1st Further Information

Proposed Temporary Warehouse (Excluding Dangerous Goods Godown) with Ancillary Facilities and Associated Filling of Land and Pond for a Period of 3 Years in "Other Specified Uses" annotated "Comprehensive Development to include Wetland Restoration Area (1)" Zone, Various Lots in D.D. 104, Nam Sang Wai, Yuen Long, New Territories

(S.16 Planning Application No. A/YL-NSW/380)

DWG. TITLE: LAYOUT PLAN

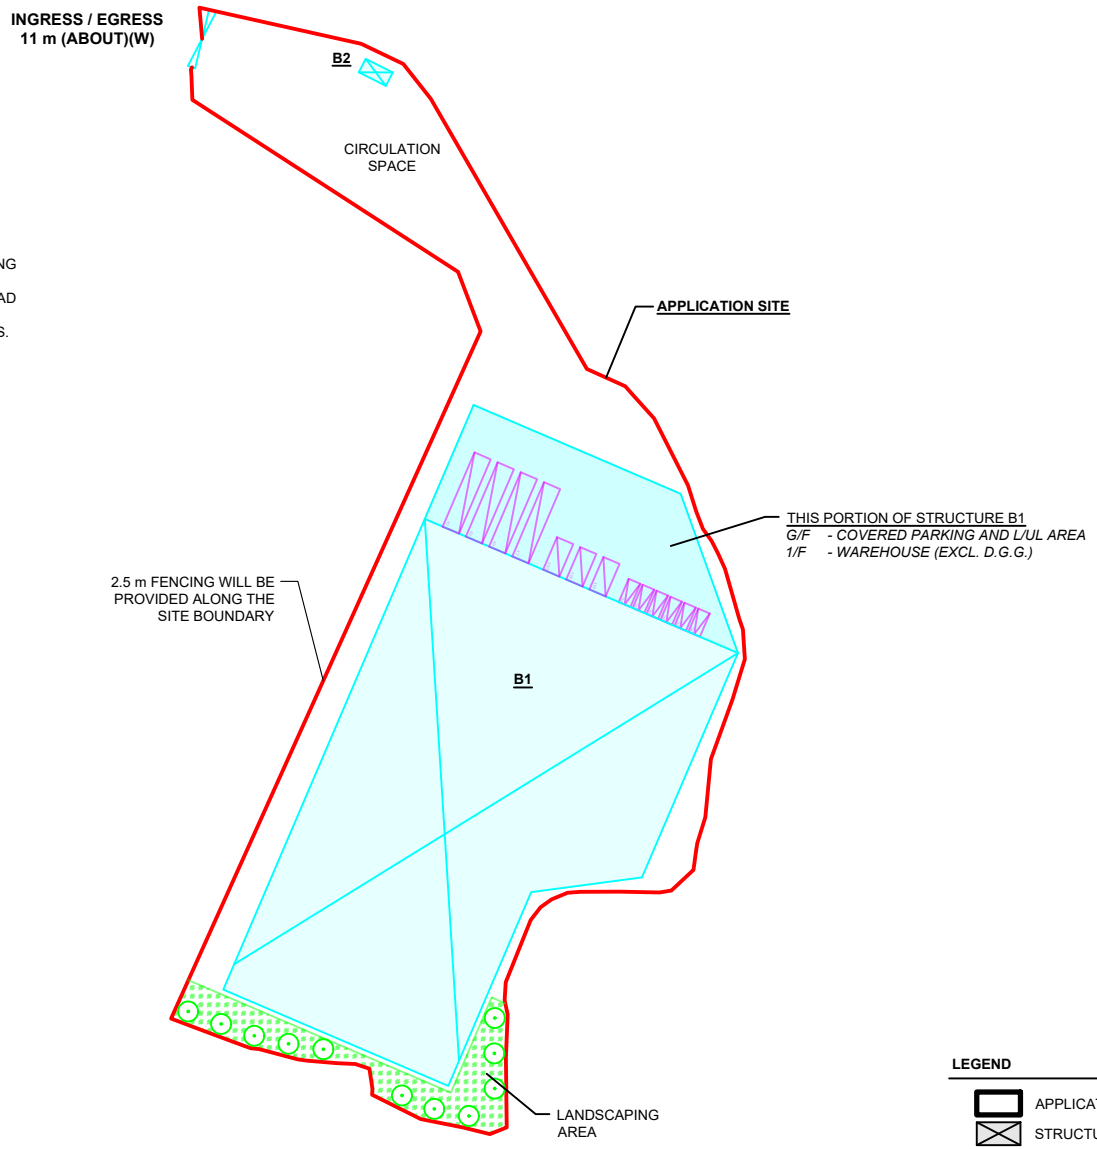
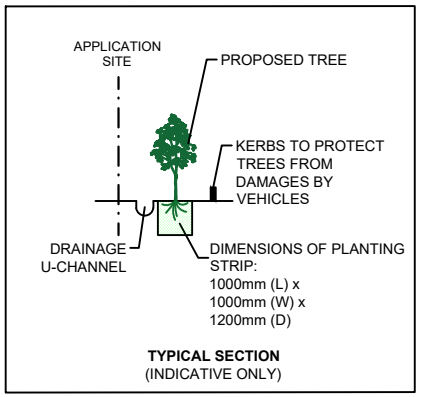
(1)	Please state the number and location of sides of the covered parking and load/ unloading spaces, and supplement a figure to facilitate our understanding.	A total of 6 parking spaces for private cars; 3 loading/unloading (L/UL) spaces for light goods vehicles and 4 L/UL spaces for container vehicles are provided within the application site (the Site). All spaces and L/UL activities are located within enclosed Structure B1. Please refer to the updated layout plan (**Appendix II**) for your reference.

(2)	The access road is narrow and will be used by heavy vehicles. It is noted that not more than 10 nos. of staff will be stationed on site. Please clarify how these staff will travel to and from the site and propose appropriate measures to ensure pedestrian safety on the access road.	6 private car spaces are provided within the Site. As there are lesser choices of public transport in the vicinity of the Site, staff are welcomed to travel to and from the Site by private cars. Staff will be deployed by the applicant to direct vehicles entering/exiting the Site. This is to ensure pedestrian safety from passing through the Site entrance. 'Beware of Pedestrian' and 'Stop' signs will be shown at the ingress/egress to ensure pedestrian safety.

- A landscape area is provided near the southern boundary of the application site (the Site). Within the landscape area, a total of 11 trees (i.e. Bauhinia Blakeana) (T1 to T11) will be proposed to be planted within the landscape area as a landscape barrier from the nearby environment. The proposed 11 new trees will be planted at least 1.2m soil depth for better tree health. The proposed trees are for mitigating any potential visual and landscape impact (if any) towards nearby sensitive receivers. The new trees planted within the Site will be maintained by the applicant in good condition during the planning approval period. Please find the revised layout plan at **Appendix II**;

DWG. TITLE: FILLING OF LAND AND POND

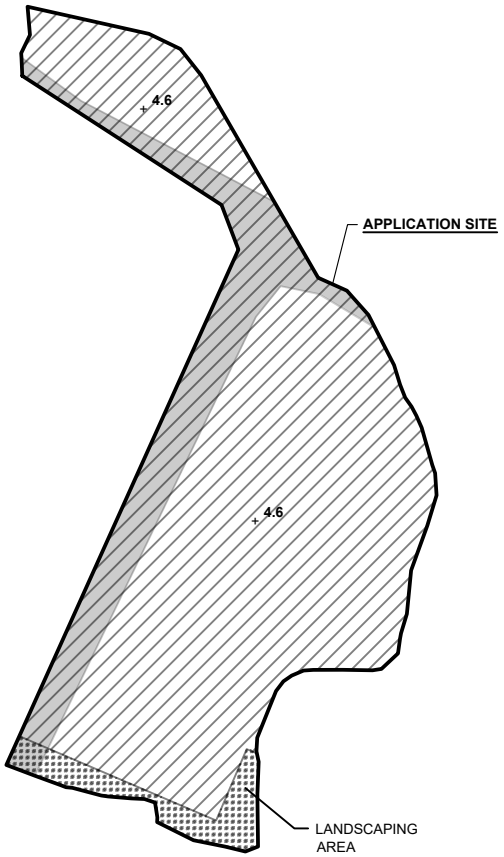
- The applicant would like to submit a revised land and pond filling plan for the consideration of Government Bureaux/departments (**Appendix IV**); and
